<b>Subject:</b> <b>POPPING AND/OR SQUEAKING NOISE FROM FRONT SHOCK ABSORBER</b>	<b>Bulletin No:</b> 02-004/15
	<b>Last Issued:</b> 05/12/2015

2014-2015 Mazda3 vehicles (Japan built) with VINs starting with JM1

2014-2015 Mazda3 vehicles (Mexico built) with VINs starting with 3MZ

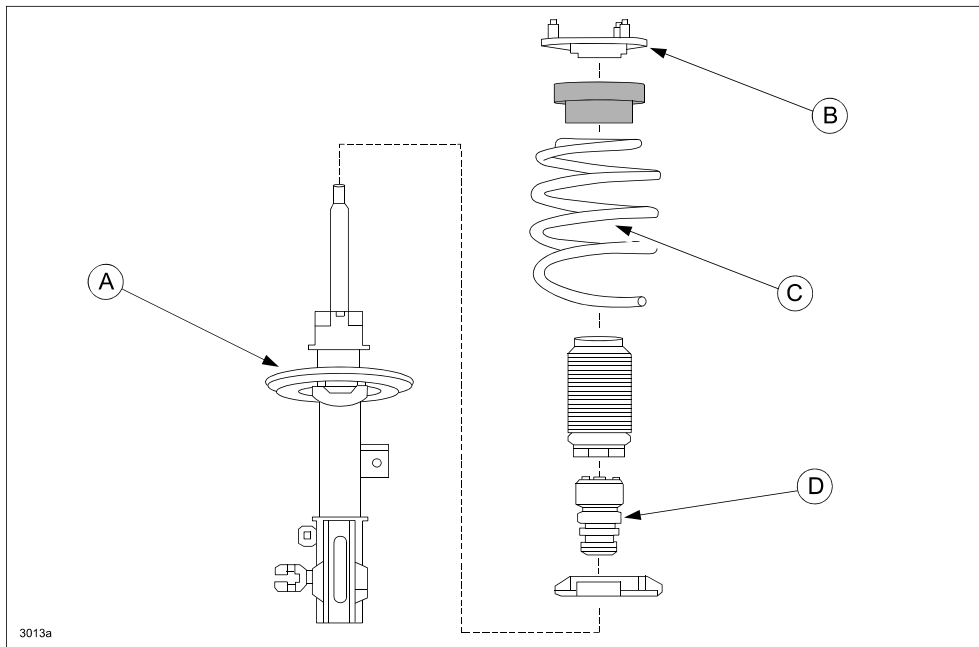
To correct the problem, the shape of the bump stopper has been modified and a protector has been installed onto the coil spring.

3013a

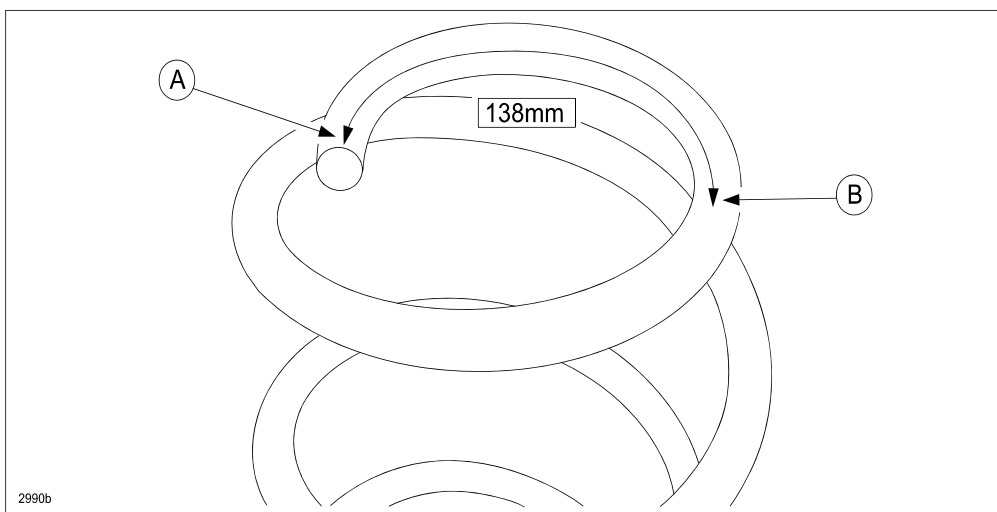
1. Verify the customer concern of noise coming from the upper part of the shock absorber when turning the steering wheel and/or driving over bumps.
2. Replace the bump stopper with the modified one according to MS3 online instructions or the Workshop Manual (section 02-13 FRONT SHOCK ABSORBER AND COIL SPRING DISASSEMBLY/ASSEMBLY).

- Before removing the mounting rubber, mark its original position so it can be re-installed later to the same position.
- When replacing the bump stopper with a modified one, apply grease to upper side of the bump stopper and to the inside of the bump stopper (on the surface that contacts the damper rod).

2990b

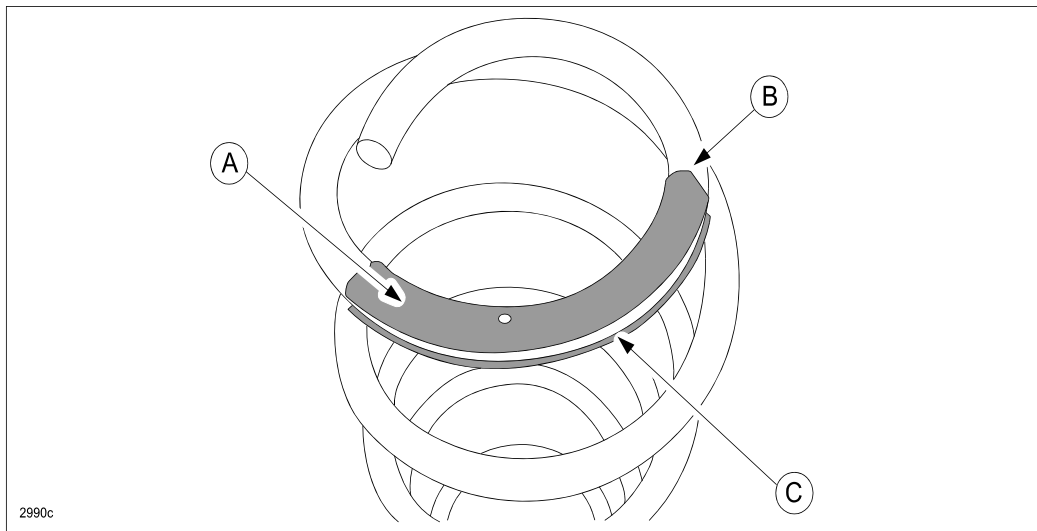
3. Install the protector onto the coil spring.
  - a. Degrease 1.5 turns of the spring from the top.
  - b. Cut a thin strip of paper to 138 mm in length (or use a cloth type measuring tape).
  - c. Place the strip of paper (or cloth measuring tape) along the inner side of the coil spring starting at point (A).
  - d. Mark the spot on the spring where (B) is. (B) is the starting point for the protector installation.

- e. Install the protector (A) onto the coil spring aligning the end (slant cut side) with the marking at spot (B).

**NOTE:** Install the protector so the gap (C) is evenly aligned around the outer edge of the coil spring.
